City of Portland, Maine - Building or Use Permit Application
 389 Congress Street, 04101 Tel: (207) 874-8703, Fax: (207) 874-8716

Past Use: Single Family	Proposed Use: Same: Amendment to Permit # 01-0562. To Add a Cantilever Deck	Permit Fee: \$30.00	Cost of Work: \$500.00	CEO District: 3
-----------------------------------	---	-------------------------------	----------------------------------	---------------------------

BUILDING PERMIT REPORT

DATE: 23 July 2001 ADDRESS: 80 Chesley Ave. CBL: 439-C-009
REASON FOR PERMIT: Amendment To Permit #01-0562
BUILDING OWNER: Jeffrey D. Vincent
PERMIT APPLICANT: /CONTRACTOR SAO
USE GROUP: R-3 CONSTRUCTION TYPE: 503 CONSTRUCTION COST: \$500,000 PERMIT FEES: \$30,000

SECOND FLOOR FRAMING DETAIL

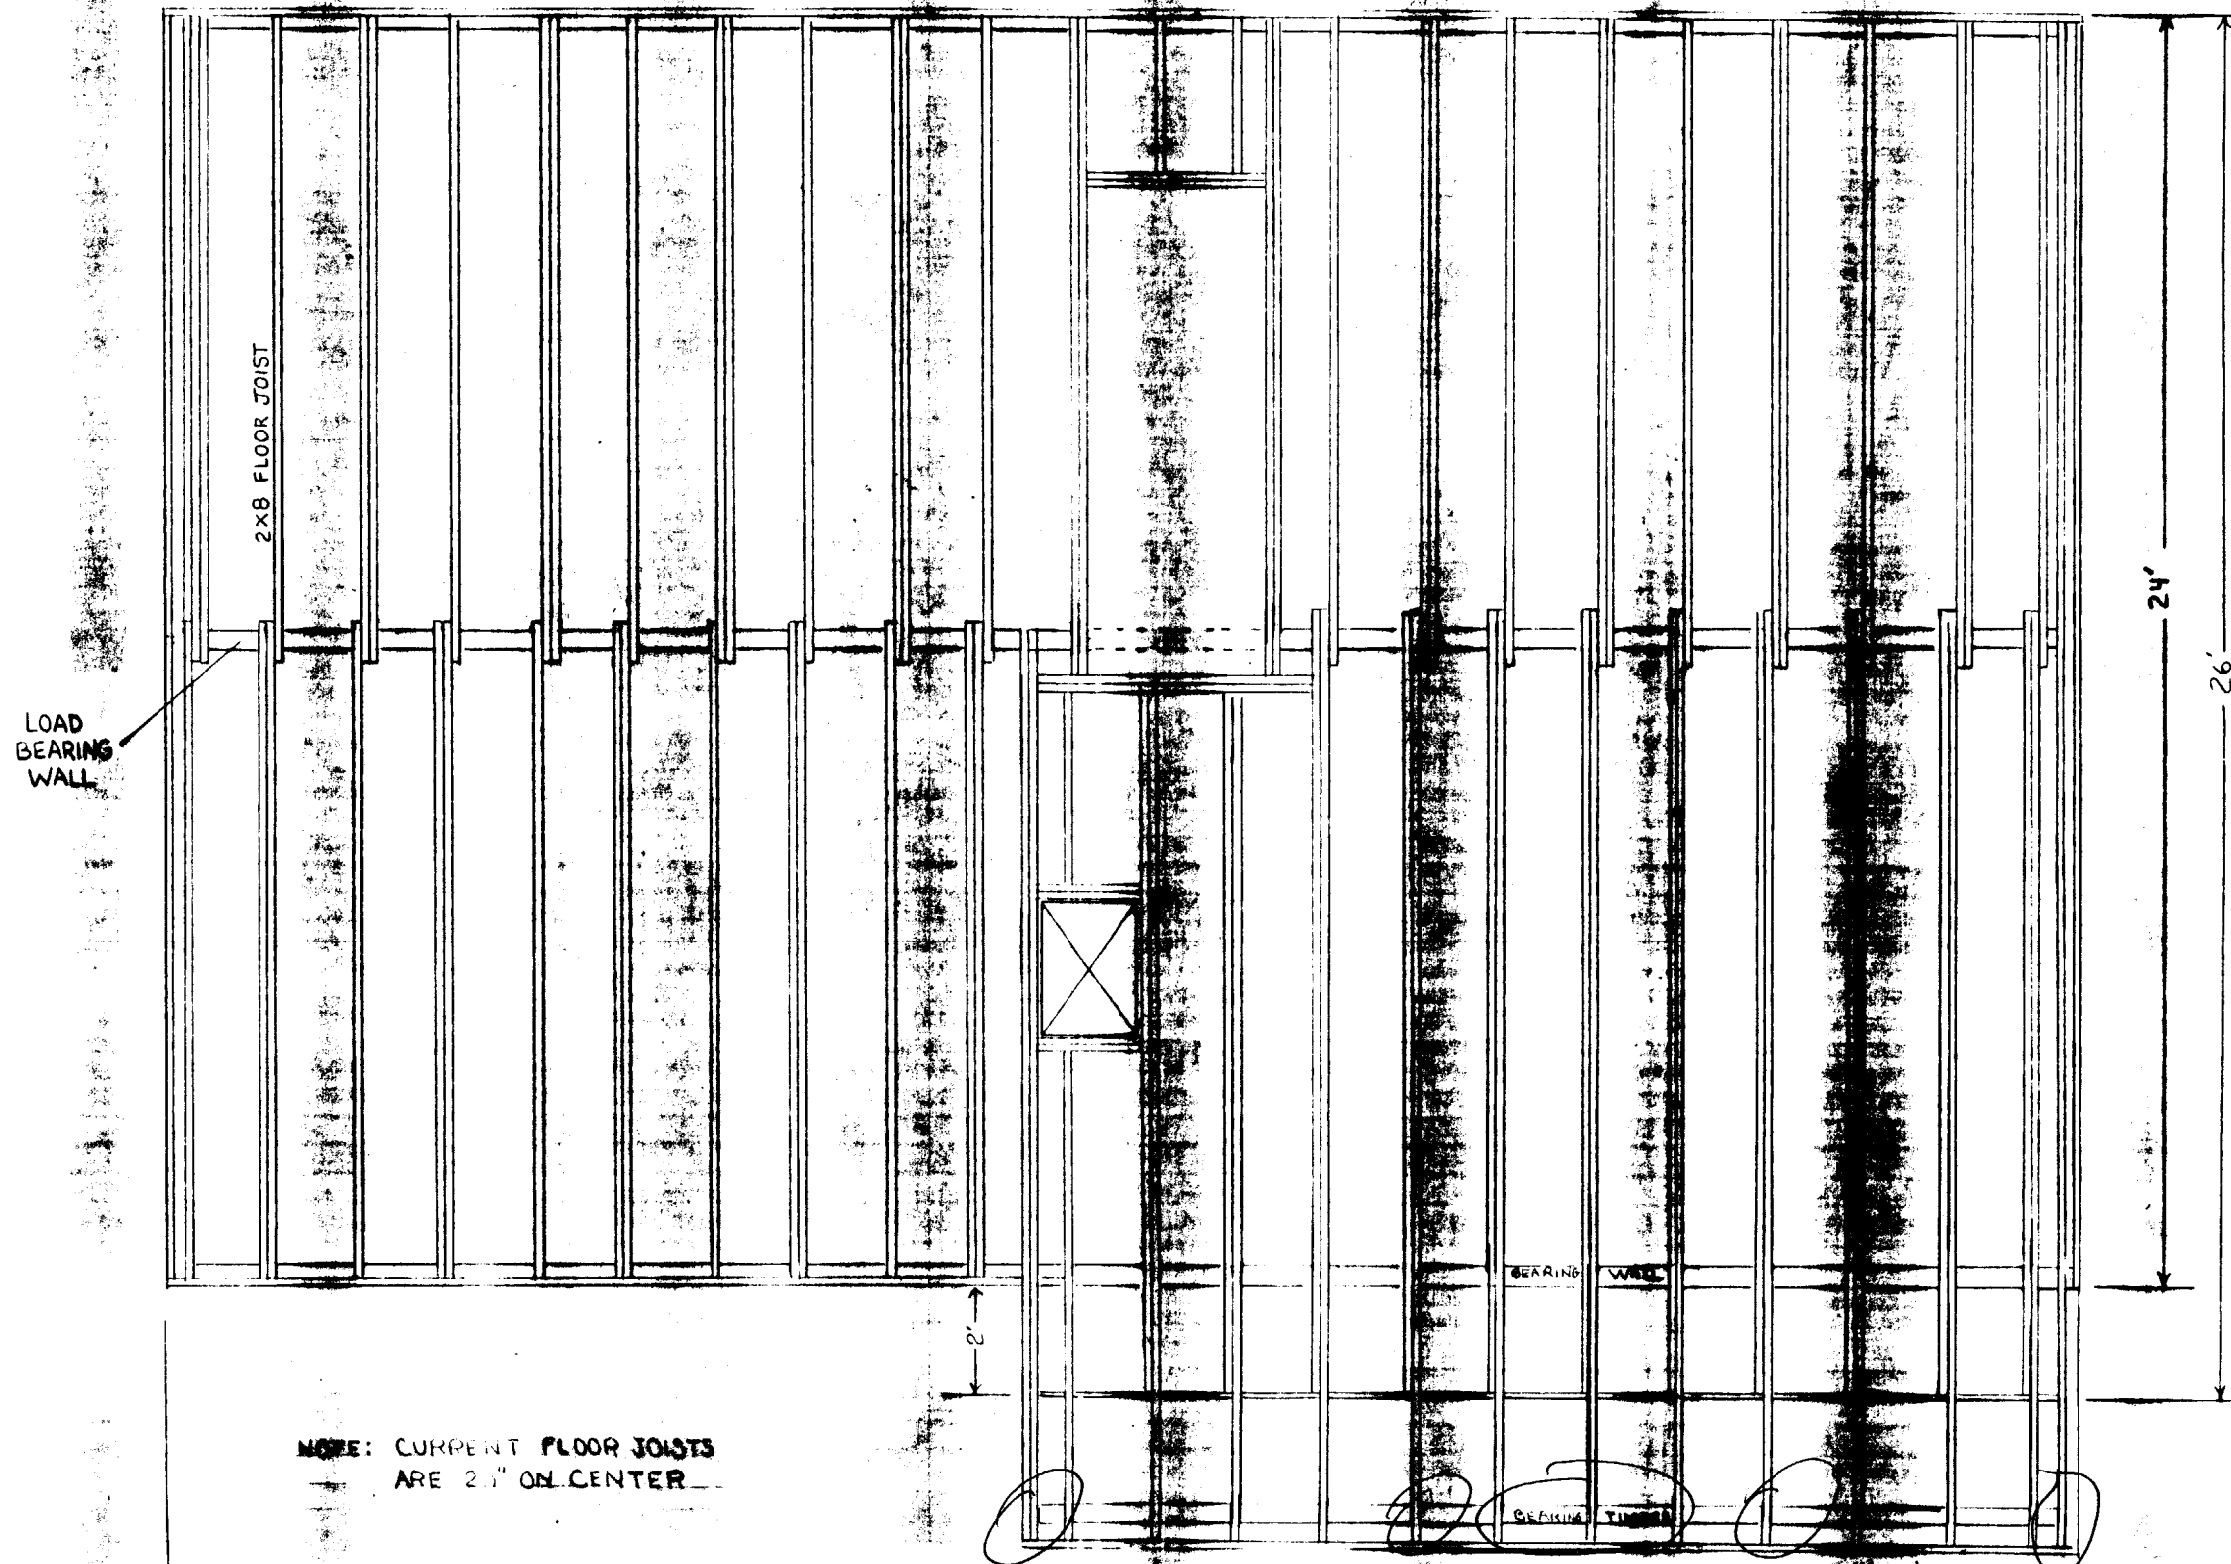
ORIGINAL APPROVAL REQUIRED DOUBLE 2x8 JOISTS ON EVERY OTHER JOIST DUE TO
 20 INCH ON CENTER. PETITIONER PROPOSES DOUBLE 2x8 JOISTS IN CANTILEVER
 SECTION. THE PROPOSED ADDITION FALLS WITHIN THE ORIGINAL FOOT PRINT
 AND THE ADDITIONAL 40 SQUARE FEET STILL COMPLIES WITH 80% REQUIREMENT.

38. *MAX. Cantilever 2' - as per Tele. conversation on 23 July 2001 -*
39. *All previous conditions and requirements are still in force.*

AMENDED SECOND FLOOR DETAIL WITH ADDITIONAL 2'x20' CANTILEVER OVER ENTRY

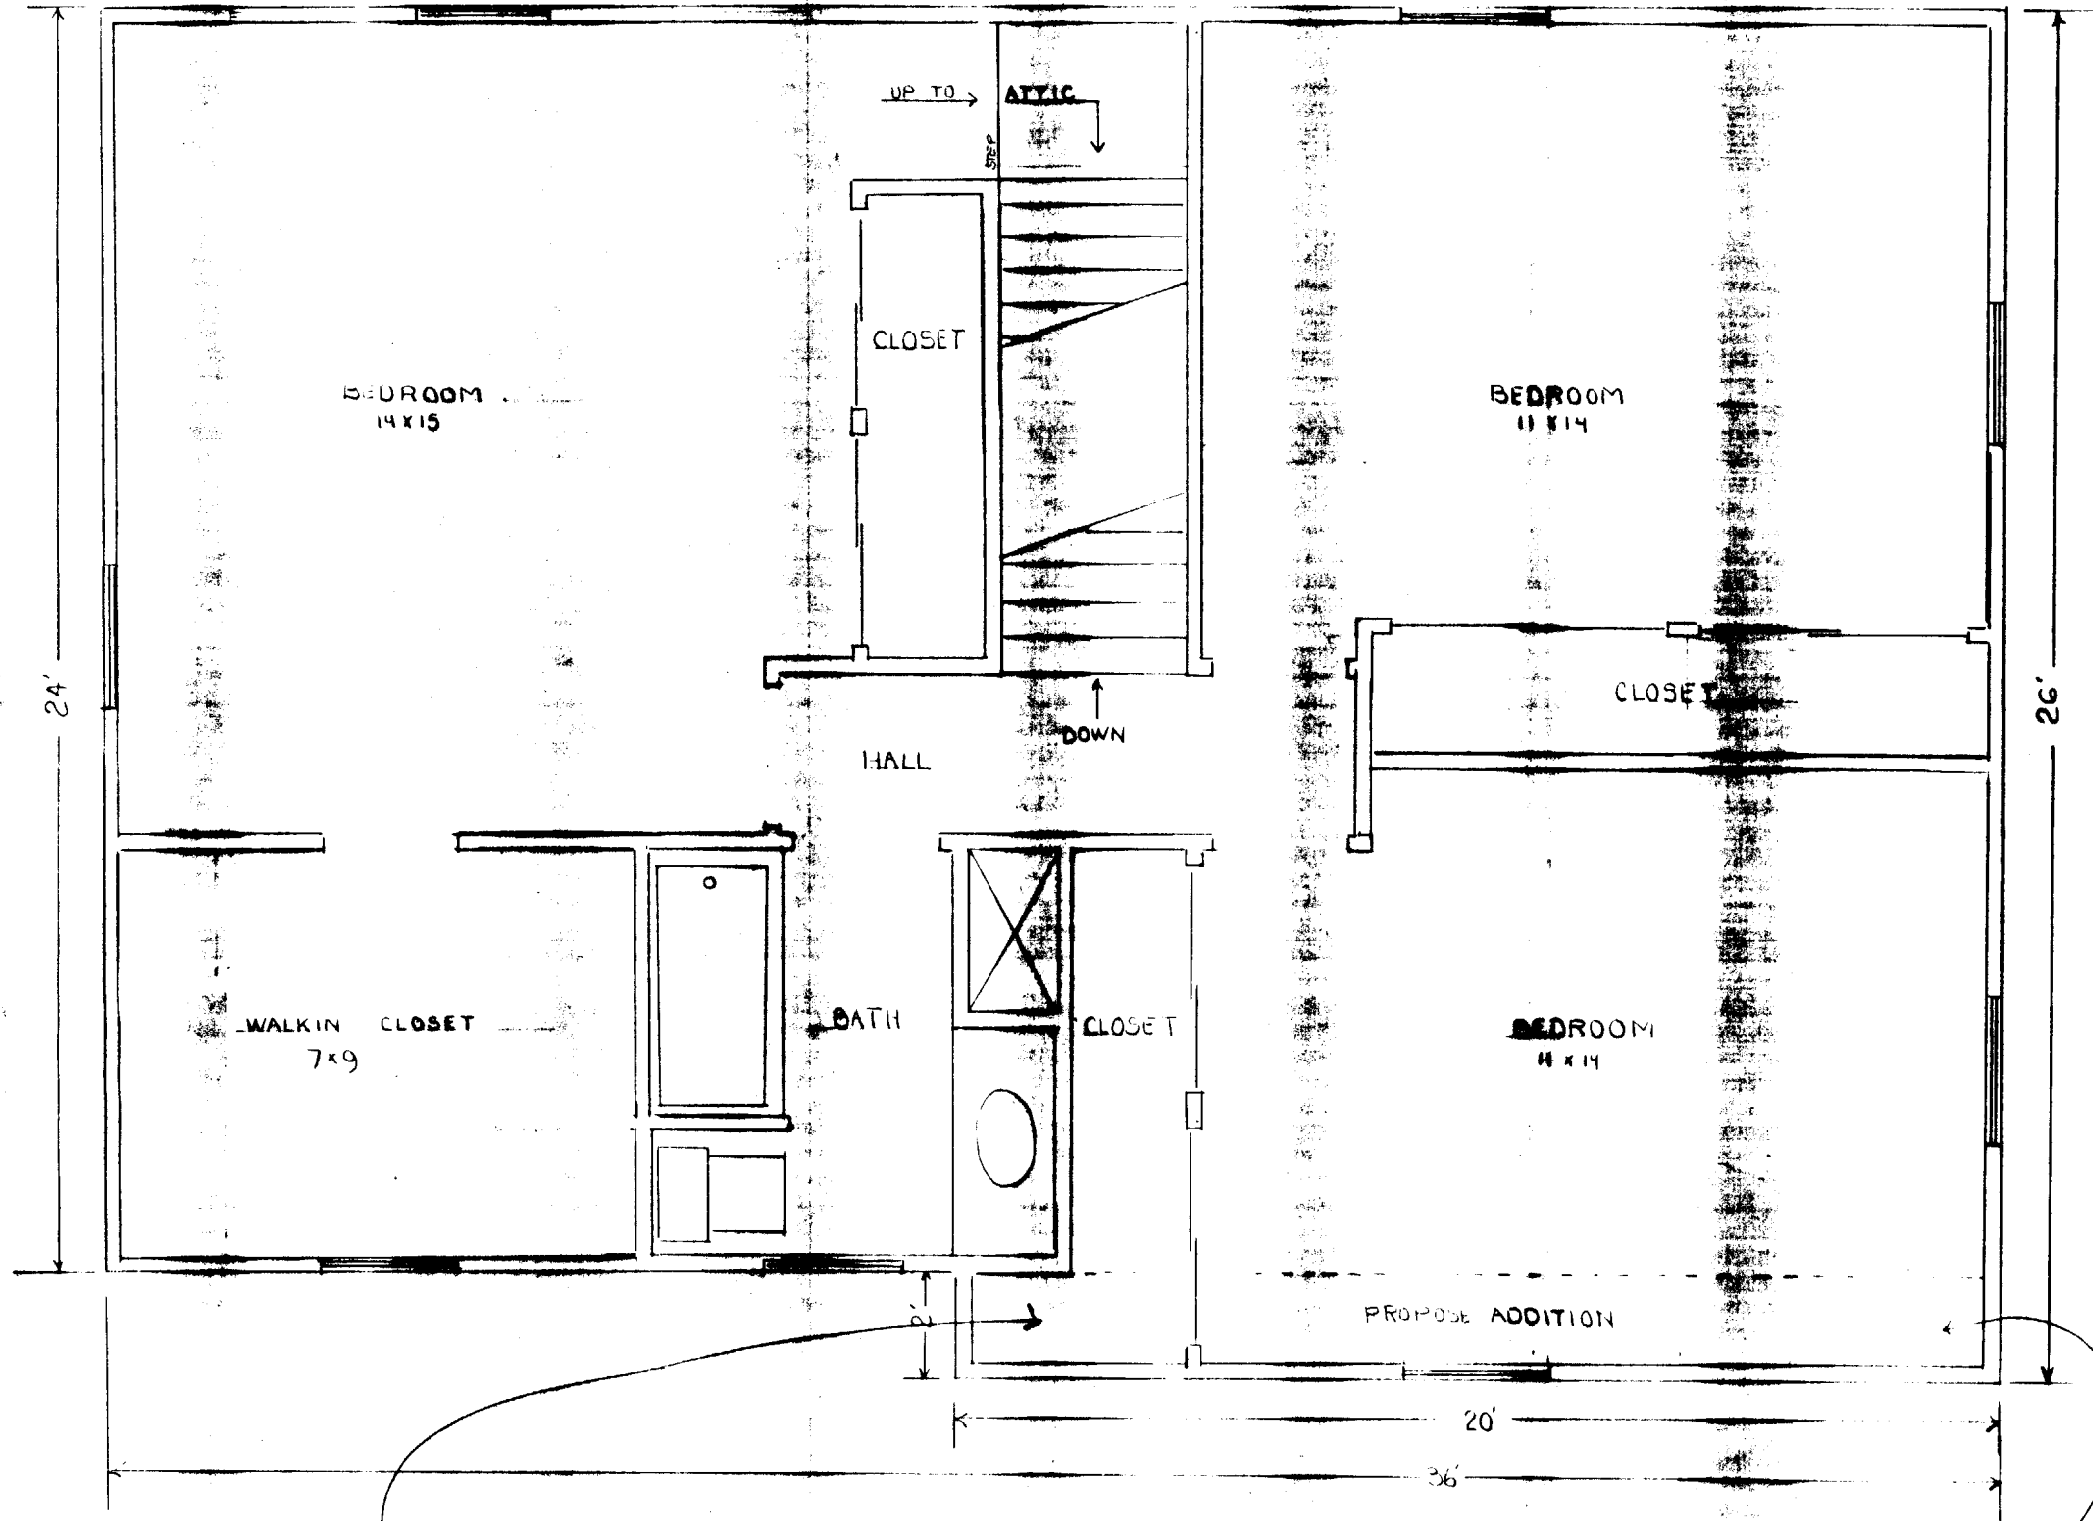
NOTE: AMENDMENT WOULD ADD 24" BY 20' EXTENSION
 THAT WOULD BE WITHIN THE FIRST FLOOR FOOTPRINT
